MEMORANDUM

Subject: Festival Industrial Development (PZ25-12000024)
2900 West Sample Road
Minimum Driveway Stacking Lane Distance Variance Request Review
WA_PLAN_2025-#003

Drawing Title
**SITE TRAFFIC
EXHIBIT**

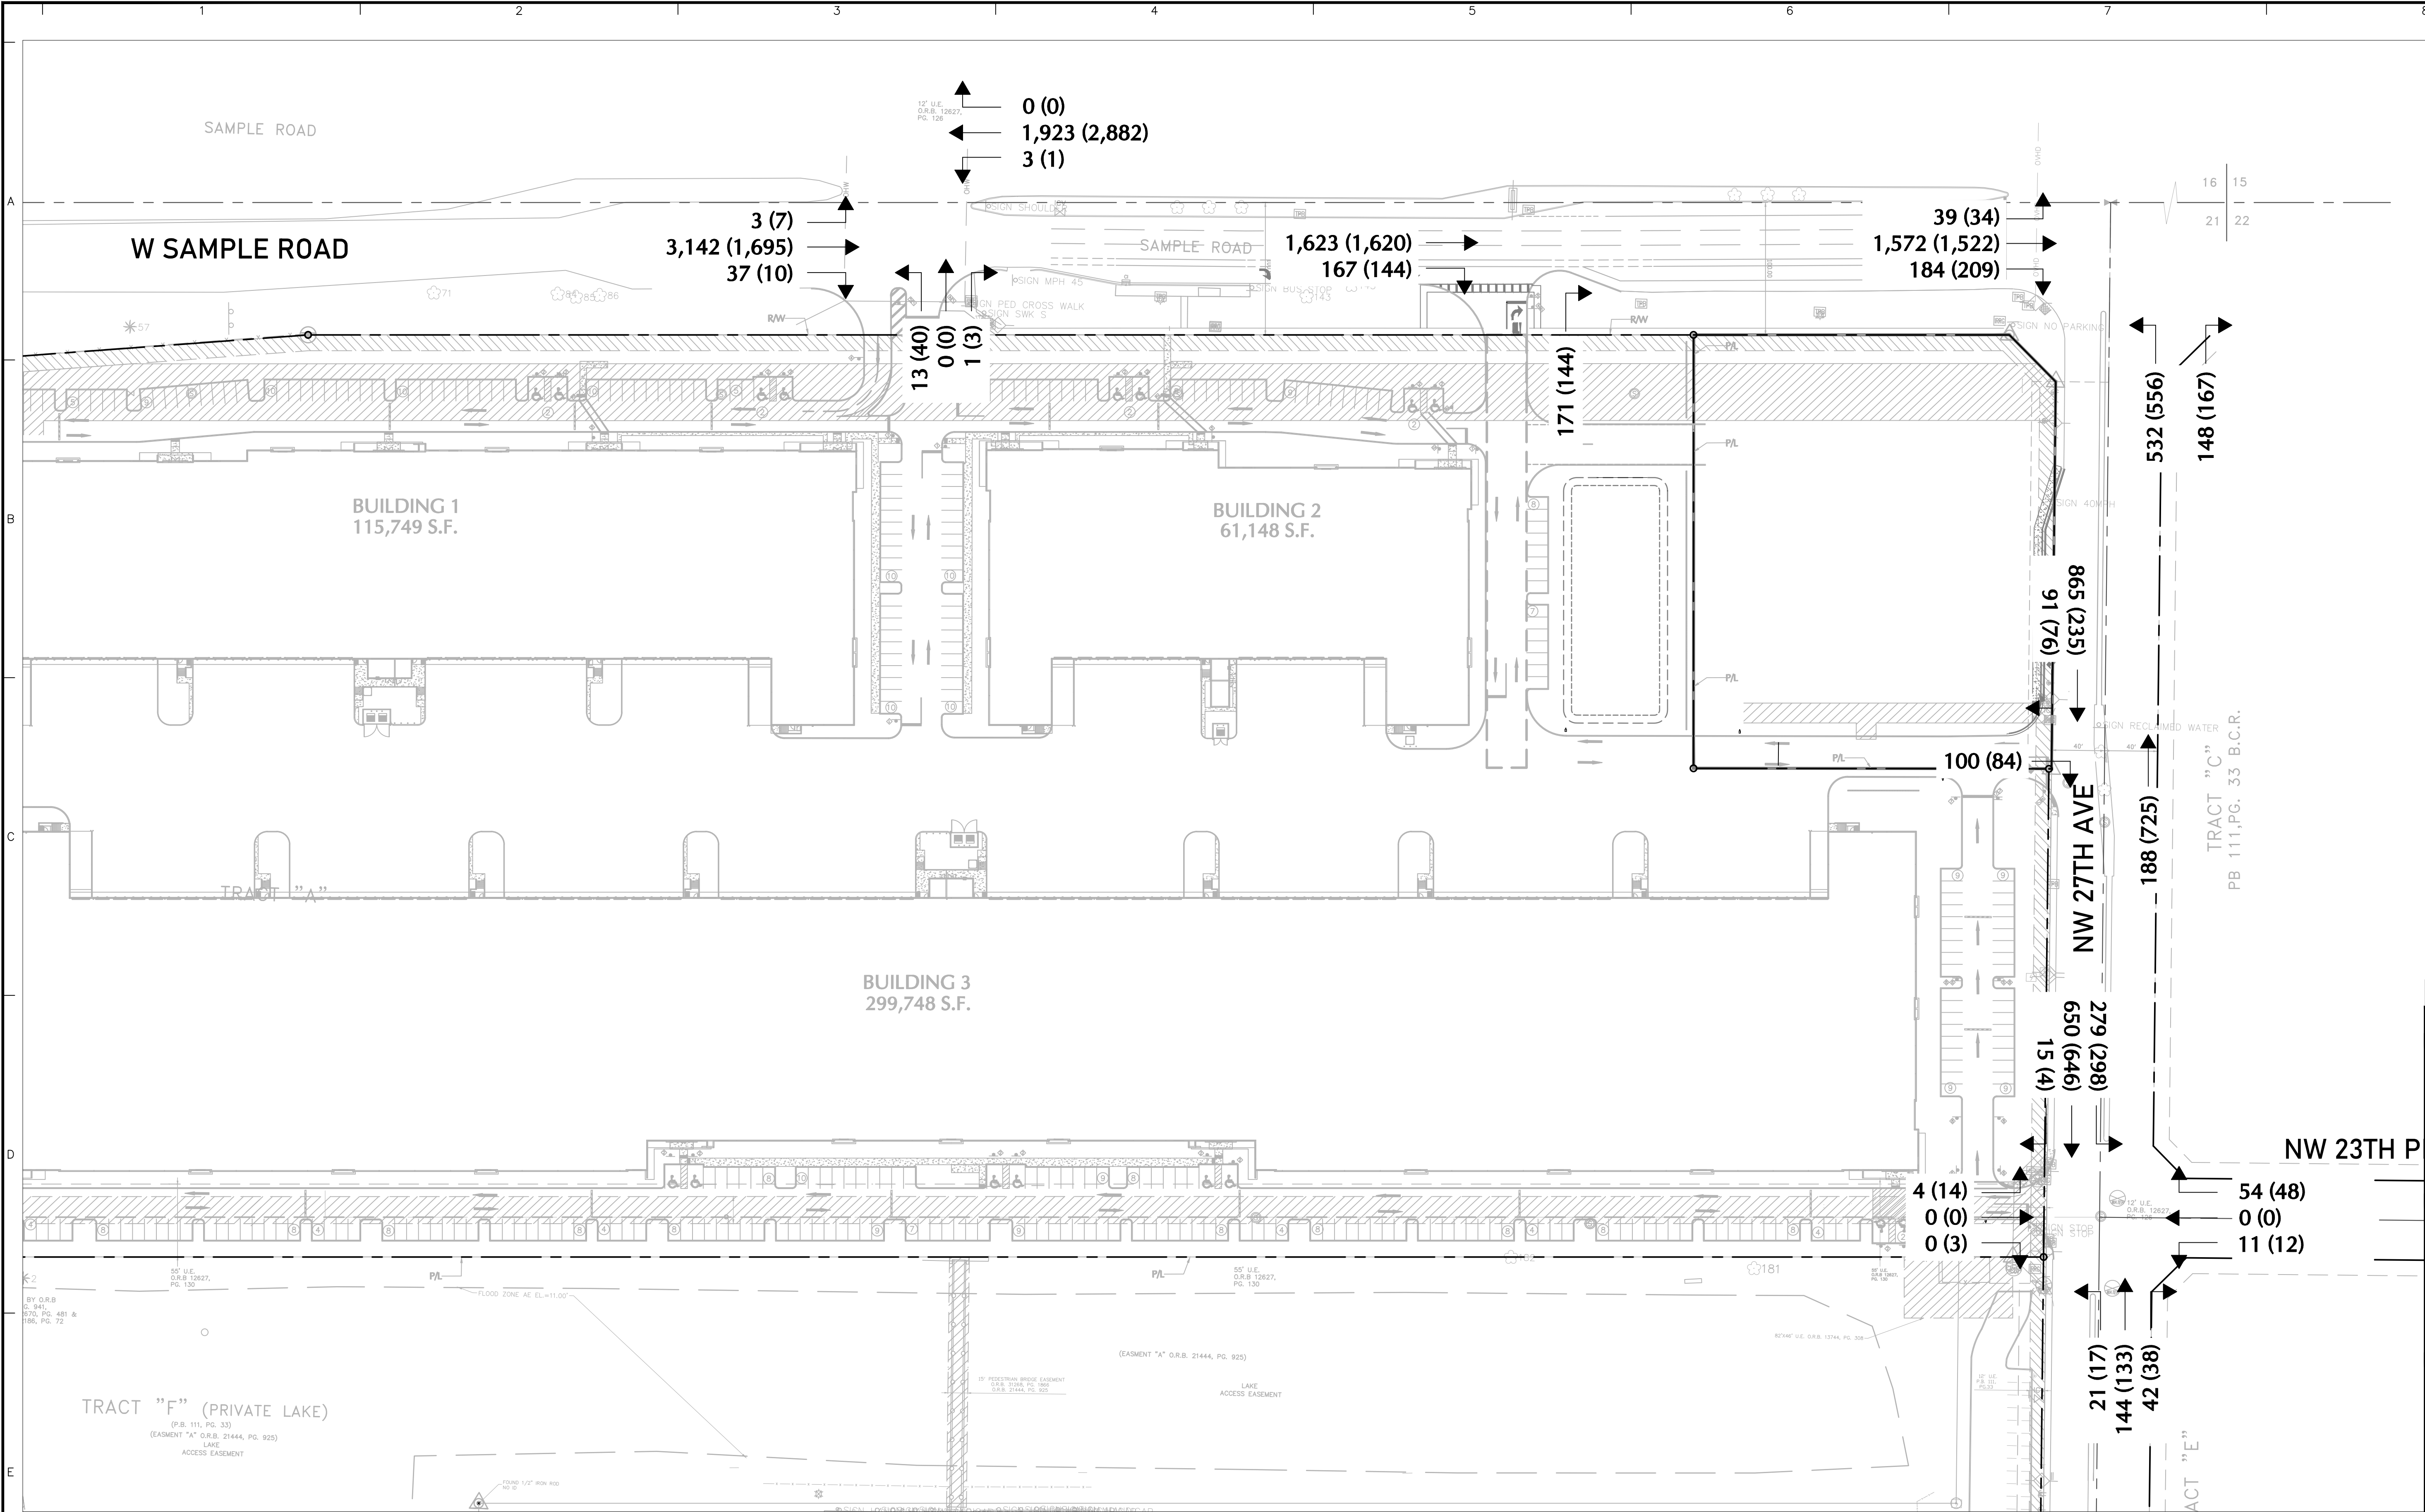
- Driveway 1 (Ingress) provides 100 feet of driveway length for the ingress lane:
 - o The MAMH does not provide specific criteria for entering driveway lengths but does state that driveway lengths are not applicable to all entrances. However, the applicant did provide conceptual approval from FDOT that specified a required driveway length of 100 feet which is provided on the site plan.
 - o The proposed driveway length exceeds the 75 feet recommended in NCHRP.
 - o Based upon the applicant's traffic volume assignment, this driveway is considered a minor driveway based upon the peak hour right-turning volumes which would require a minimum driveway length of 25 feet. Note that minor driveways are not typically signalized. However, because it is located at a signalized driveway, additional driveway length beyond 25 feet should be considered and is being provided.

- Driveway 1 (Egress) provides approximately 60 feet of driveway length for the egress lane with two (2) exit lanes:
 - o The MAMH does not provide specific criteria for exiting driveway lengths but does state that driveway lengths are not applicable to all entrances. However, the applicant did provide conceptual approval from FDOT for the site plan that proposes a 60-foot egress driveway length. Note that given that this driveway's entry lane does not conflict with the exit lanes for the site and the internal site intersection is proposed as all-way stop control, there is no potential for vehicles entering to conflict with queues from exiting vehicles. Therefore, given the site configuration, the driveway length of less than 100 feet is not a concern.

- Driveway 2 provides approximately 70 feet of driveway length:
 - o The MAMH does not provide specific criteria for entering driveway lengths but does state that driveway lengths are not applicable to all entrances. However, the applicant did provide conceptual approval from FDOT that required a minimum driveway length of 50 feet which is provided on the site plan.
 - o The proposed driveway length exceeds the 50 feet recommended in NCHRP.
 - o Based upon the applicant's traffic volume assignment, this driveway is considered a major driveway based upon the total peak hour volume which would require a minimum driveway length of 100 feet.

- Driveway 3 provides approximately 56 feet of driveway length:
 - o The MAMH does not provide specific criteria for entering driveway lengths but does state that driveway lengths are not applicable to all entrances.
 - o The proposed driveway length exceeds the 50 feet recommended in NCHRP.
 - o Based upon the applicant's traffic volume assignment, this driveway is considered an intermediate driveway based upon the total driveway peak hour volumes which would require a minimum driveway length of 50 feet.

- Driveway 4 provides approximately 50 feet of driveway length:
 - o The MAMH does not provide specific criteria for exiting driveway lengths but does state that driveway lengths are not applicable to all entrances.
 - o The proposed driveway length meets the 50 feet recommended in NCHRP.
 - o Based upon the applicant's traffic volume assignment, this driveway is considered a minor driveway based upon the total peak hour intersection volume which would require a minimum driveway length of 25 feet which is exceeded on the proposed site plan.

Given that the ingress configuration of Driveway 1 is under the jurisdiction of FDOT, FDOT has conceptually approved the site plan/driveway length, and the driveway length meets the guidance identified in our document review, we take no exception with the proposed configuration.

Given that egress configuration of Driveway 1 is under the jurisdiction of FDOT, FDOT has conceptually approved the site plan/driveway length, and the driveway length generally meets the guidance identified in our document review, we take no exception with the proposed configuration.

Although Driveway 2 is under the jurisdiction of FDOT and they have conceptually approved the site plan/driveway length, it is recognized that this driveway serves both the proposed industrial development and the adjacent gas station with convenience market (east) as well as being considered a major driveway based on BCC criteria. Therefore, it is recommended that to restrict the eastbound movement along the interior drive aisle to right-turn only to reduce potential conflicts that could result in queues extending into the public right-of-way along SR 834/West Sample Road.
